**VALUE ENGINEERING STUDY  
OF**

***US 41A  
HOPKINS COUNTY***

**PROJECT ITEM NUMBER: 02-0137.00**

***FINAL REPORT: AUGUST 31, 2011***

**MADISON ZONING MAP**

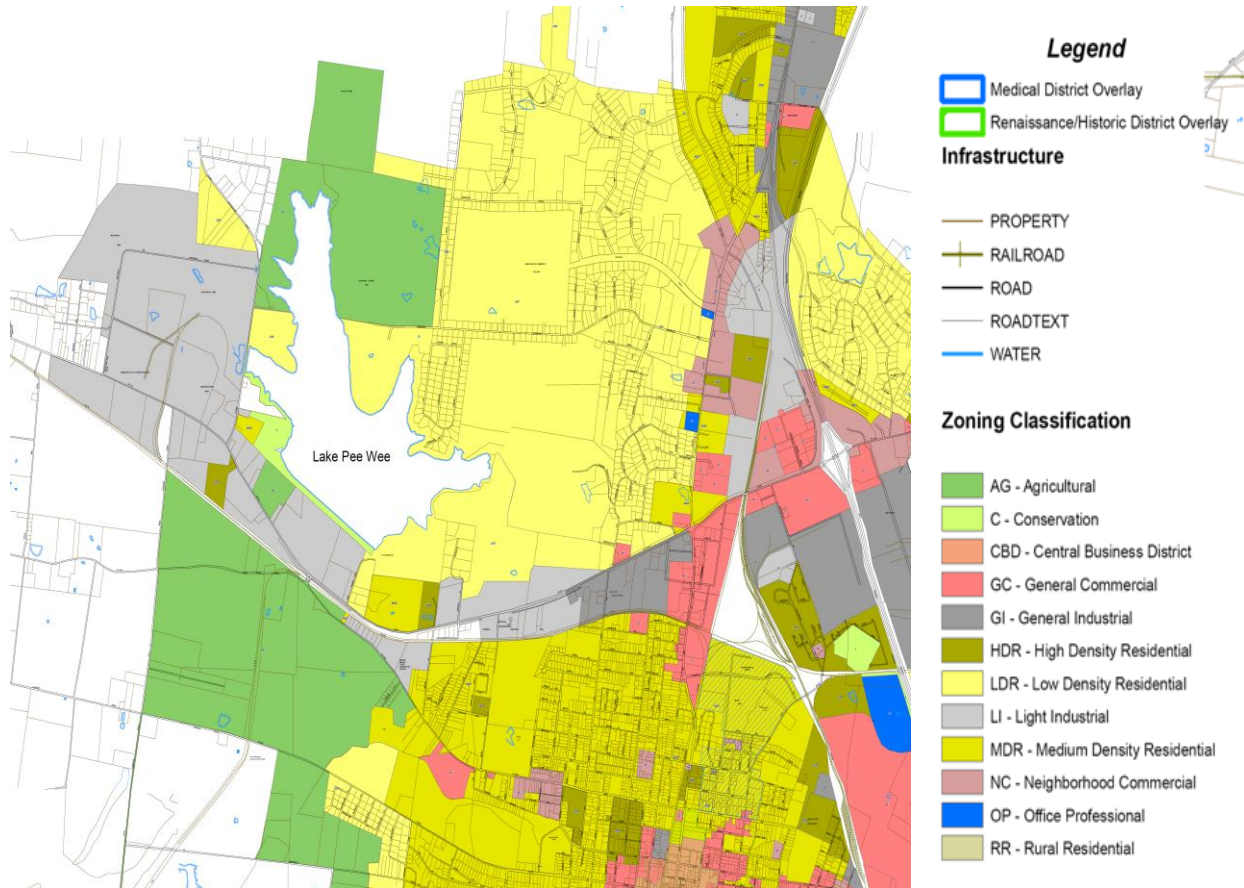
Much of the land currently does have any development or low density residential which would allow for future growth in this area.

To accommodate this growth and minimize traffic impacts on the US 41A highway, the Value Engineering Team recommends that the city, in conjunction with KYTC, develop a plan to create an interconnected road system to serve these properties as they develop. This plan would allow local officials to coordinate future development site layouts and incrementally build these roads. By carefully planning and building these backage roads, access control can successfully be preserved on US 41A while giving local traffic the opportunity to travel short distances without needing to access US 41A. This will allow the volumes on US 41A to be minimized, maximize the operational efficiency, and extend the useful life of the highway.
